# Hove Gardens, Hove Section 73 - Pre-App Report - NMA

July 2021  
CJCT  
Section 73 Report  
Planning Ref: BH2020/00917  
Rev 04

## Brief & Summary of Changes

## 2.6 East Elevation - Proposed

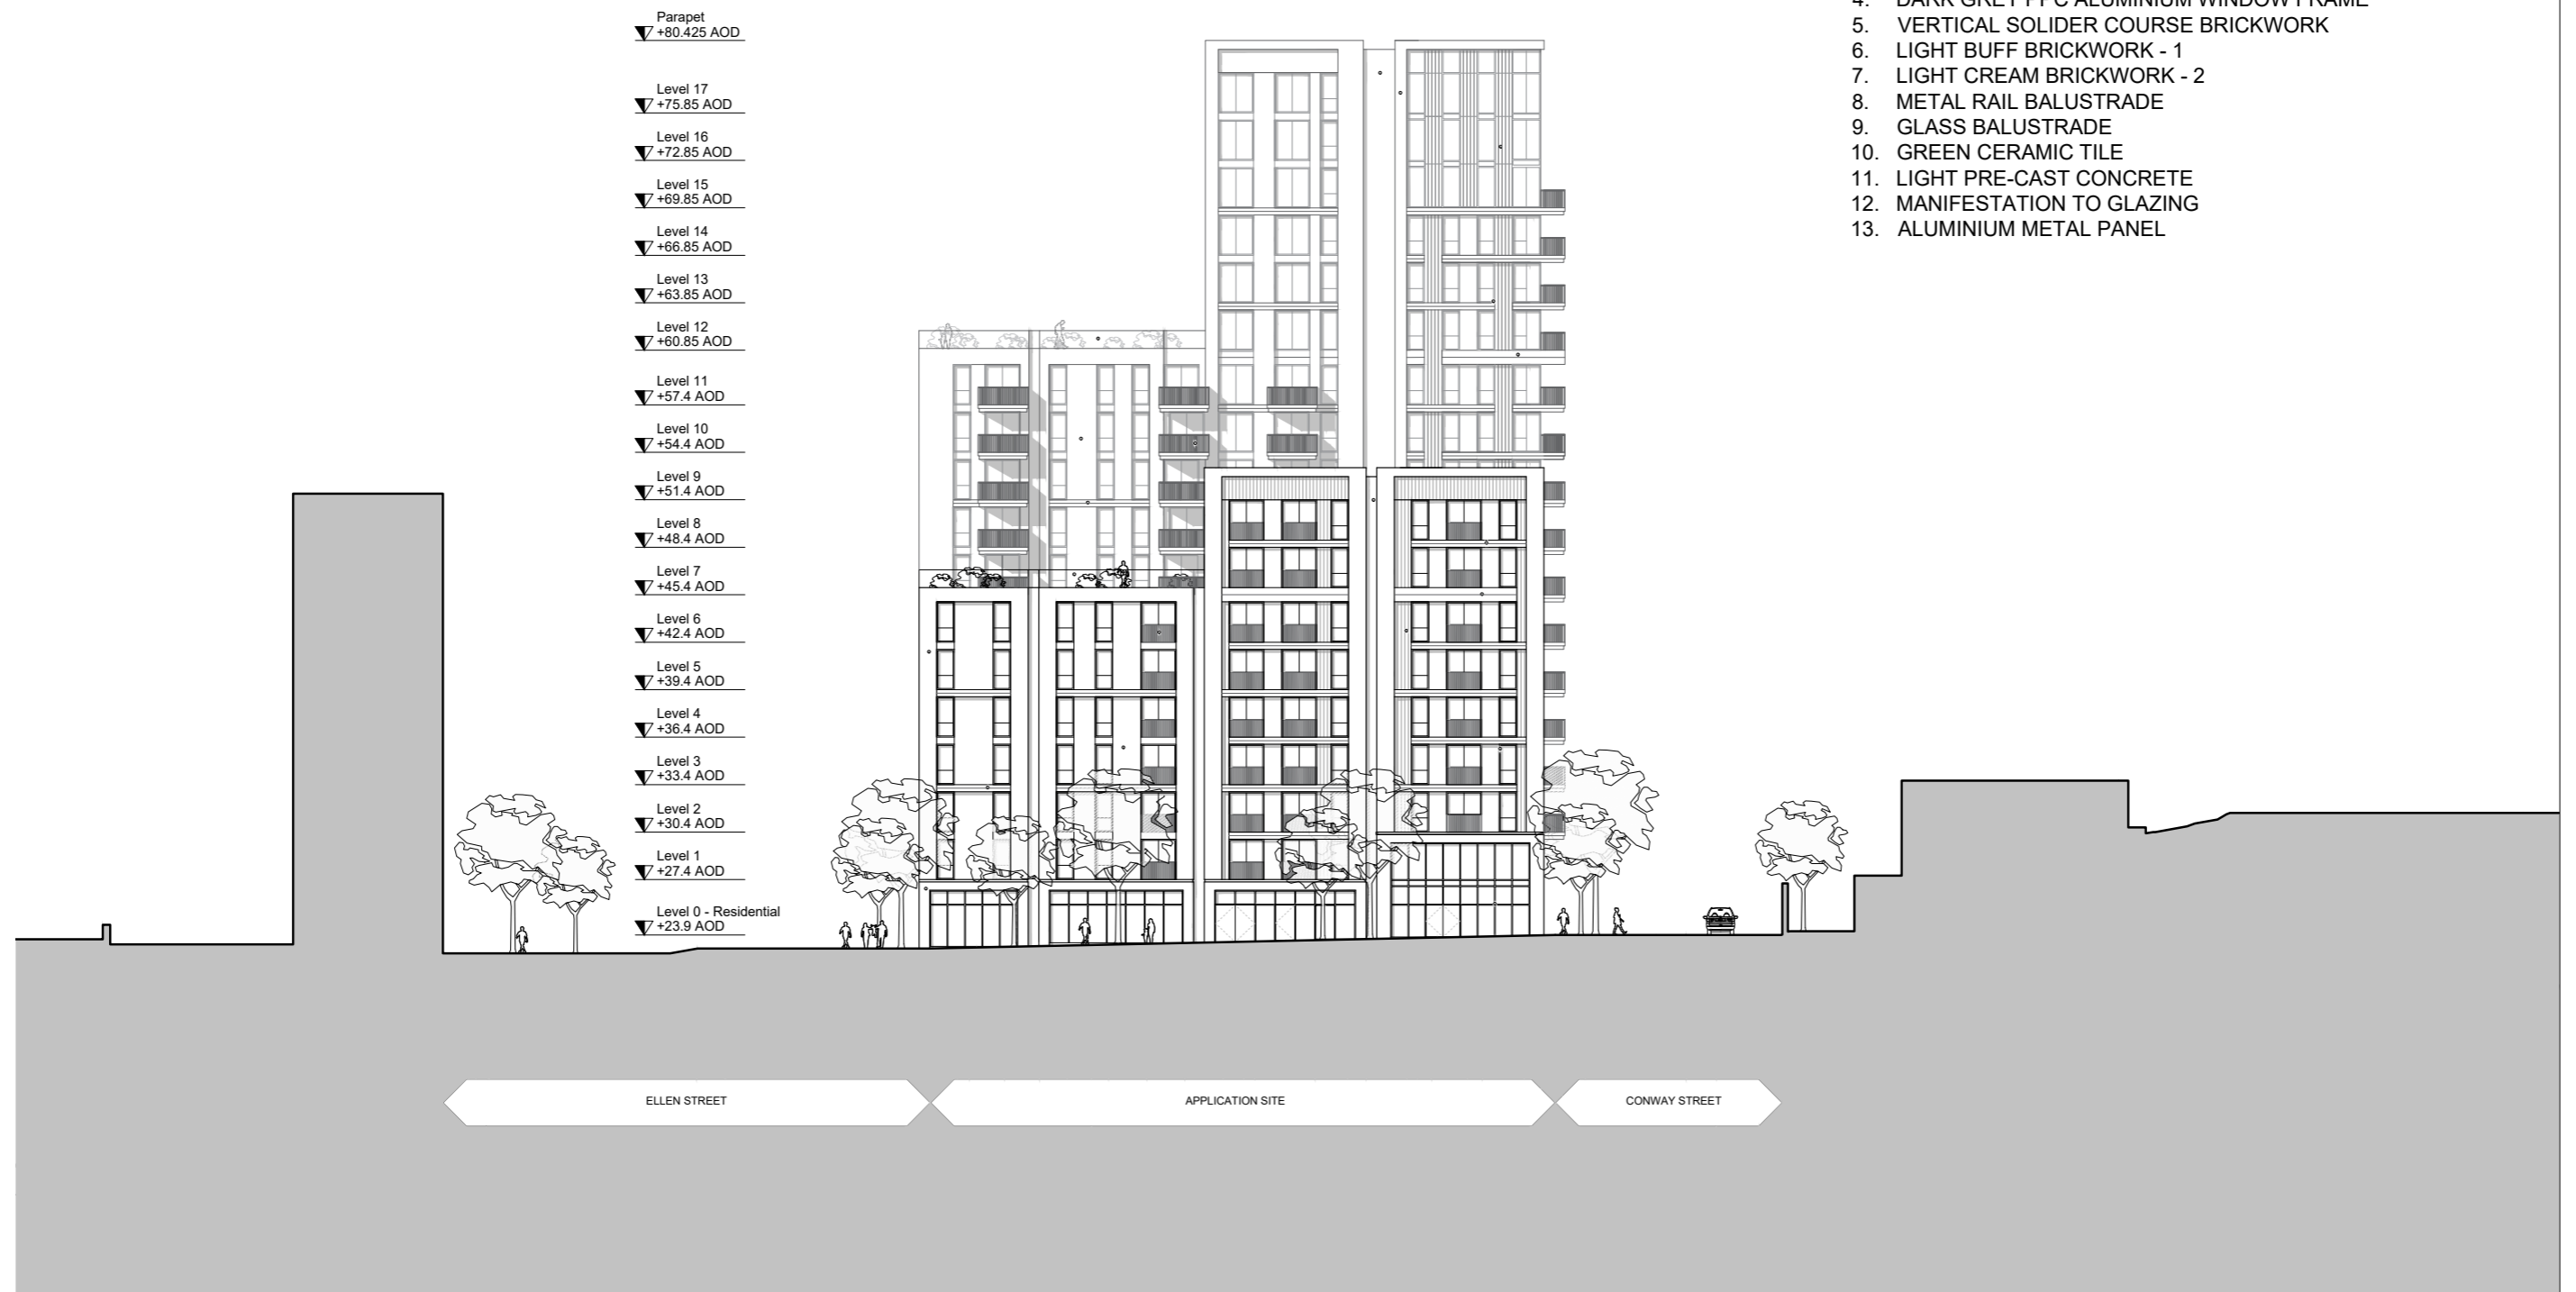
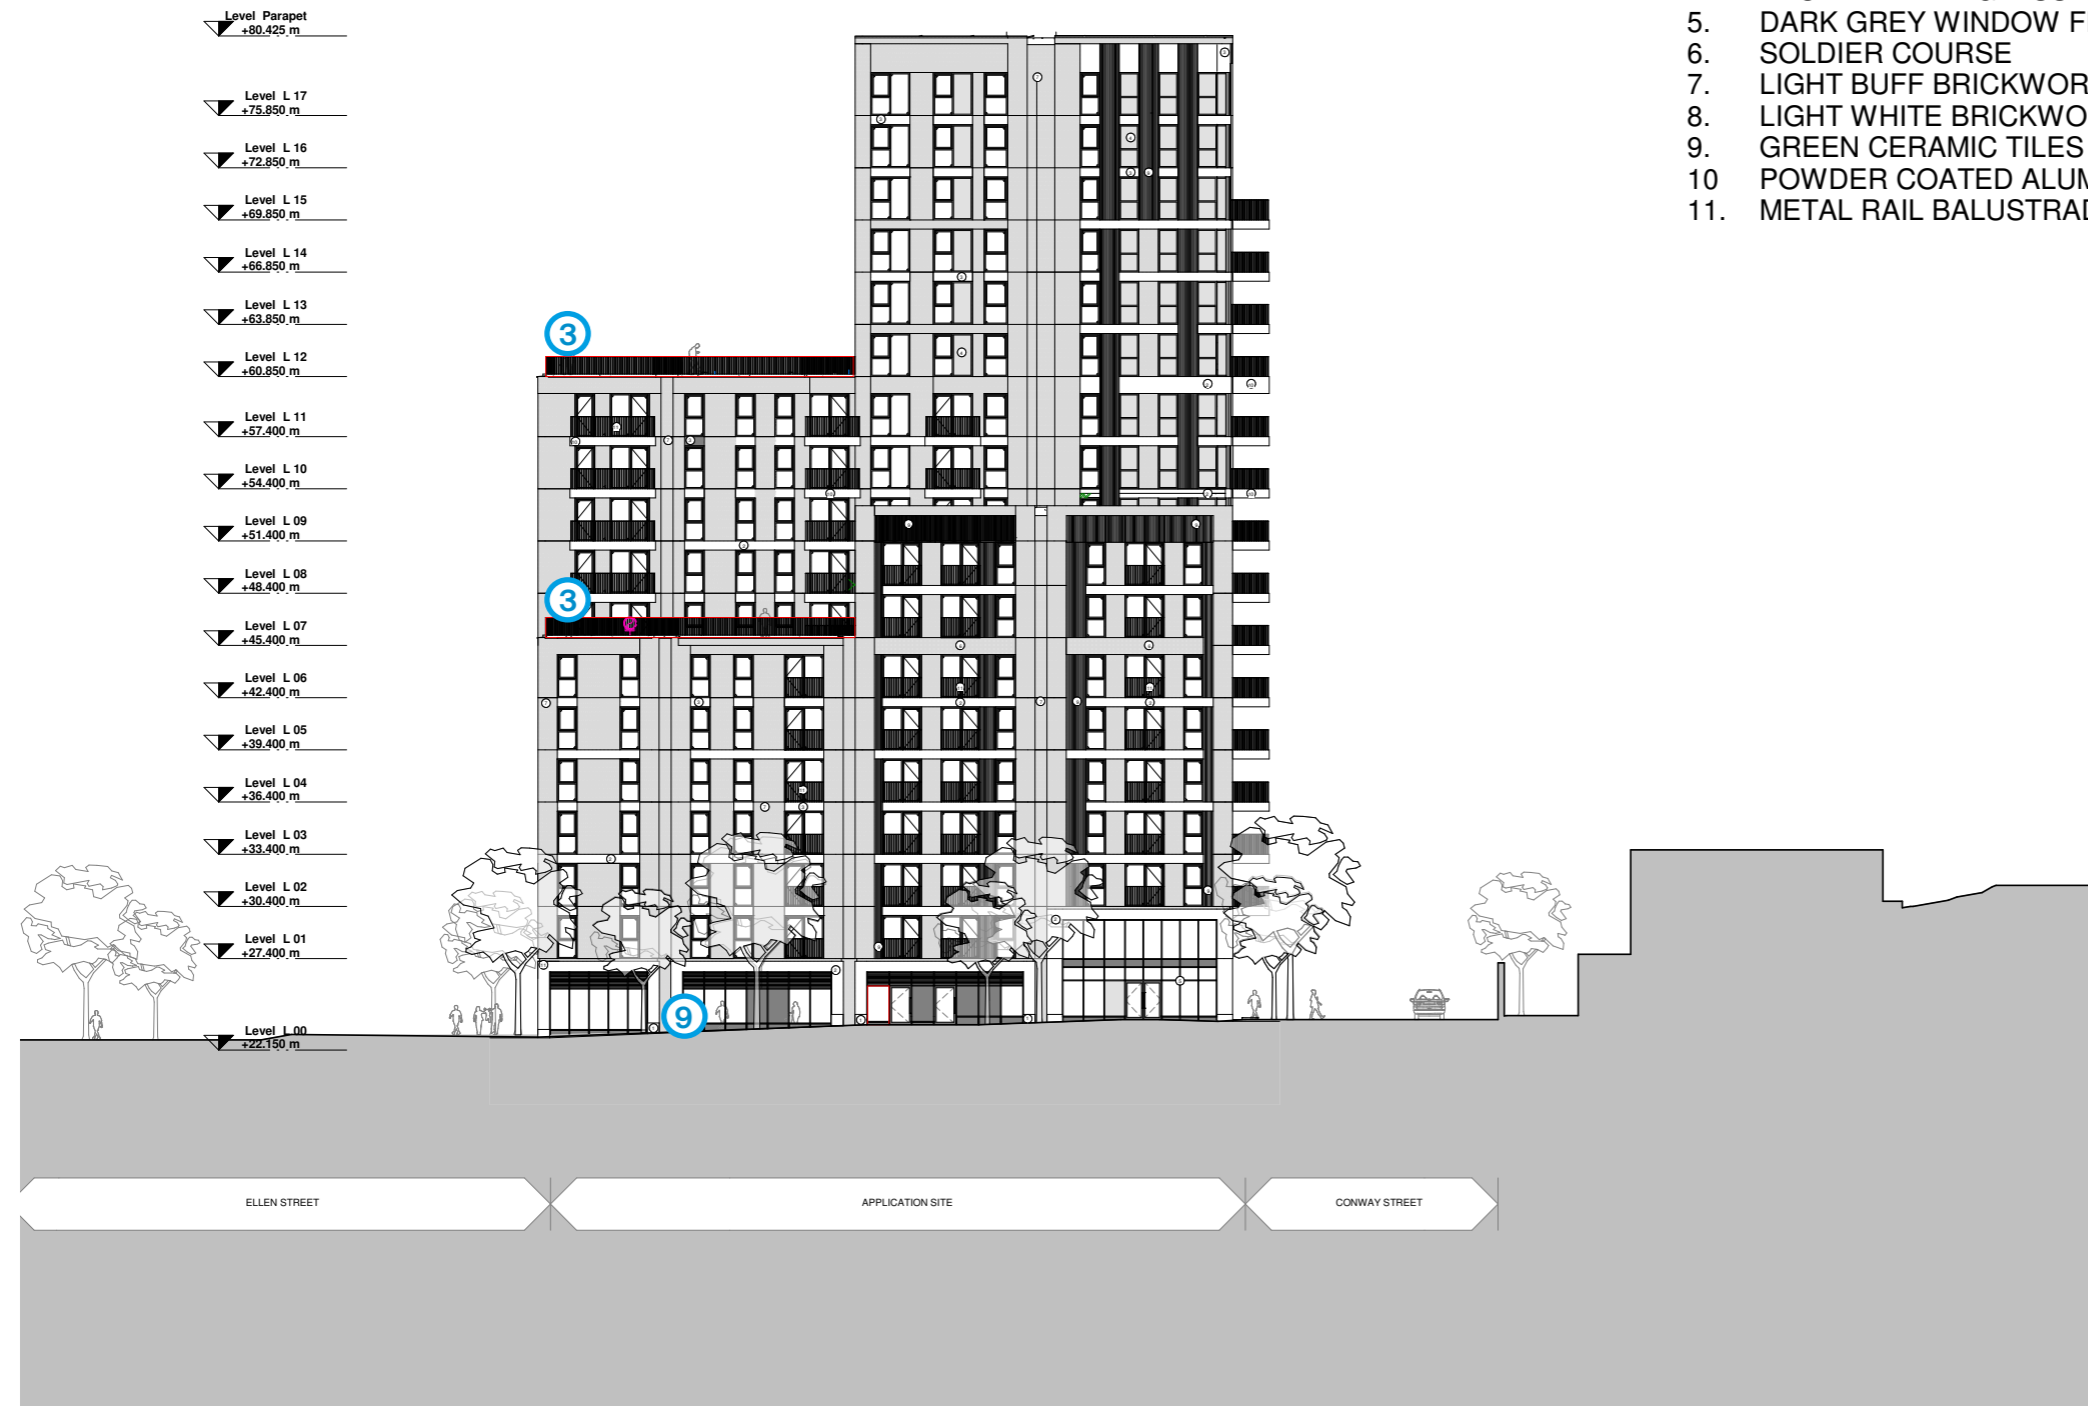
- ① Removal of slab voids to deck access
- ② Columns added to support weight of projecting deck
- ③ Balustrading updated to vertical railing
- ④ ASHP's located on level 7 roof
- ⑤ Updated ground floor layout to improve active frontage and maximise commercial offering. Dedicated Commercial Refuse Storage
- ⑥ Updated basement layout following full MEP and structural optimisation - Improved cycle storage
- ⑦ Updated landscape proposals to accommodate basement ventilation
- ⑧ Anodized Aluminium Panels
- ⑨ Dark Stone at Base
- ⑩ Omitted juliet balcony
- ⑪ Aluminium fascia at balconies
- ⑫ Solid Metal Panel to be welded to the backside of the metal railing balustrade
